# City of Albuquerque

Re: Site Plan submittal for building permit approval for Apartments, Lot 10-A, Valencia Drive (at Anderson) S.E., Virginia Place Addition, Block 6, Lot 10-A (Zone Map L-18-Z), Architect's Stamp dated 7/31/99.

***RE: Grading and Drainage Plan for Lot 10A Apartments, Block 6, Virginia Place Addition (L18/D59) Submitted for Building Permit Approval, Engineer's Stamp Dated 7/31/99.***

**RE: *Grading and Drainage Plan for Lot 10A Apartments, Block 6, Virginia Place Addition (L18/D59) Submitted for Building Permit Approval, Engineer's Stamp Dated 5/3/99.***

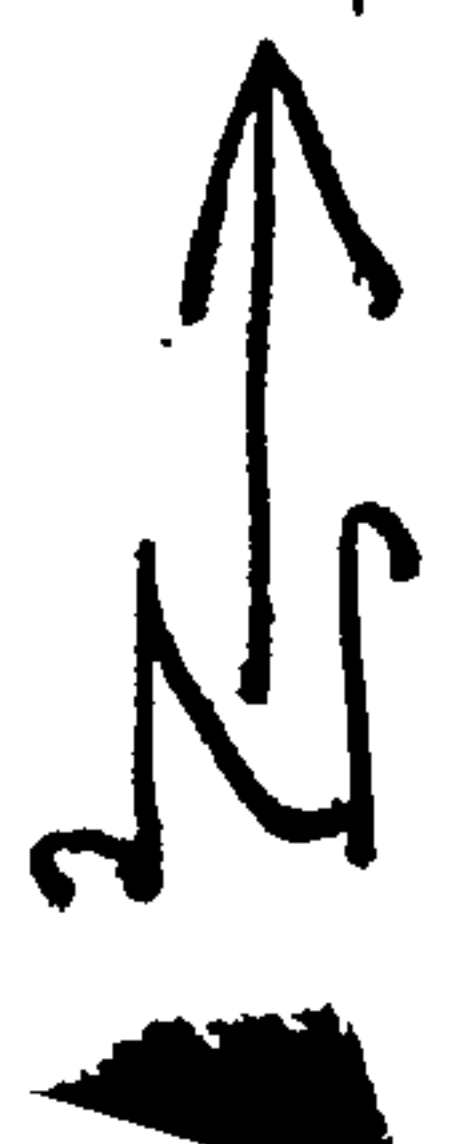
*Called Celia T. re: Need for Fence permit or revision to Permit Plans & Approval.*

Fence?
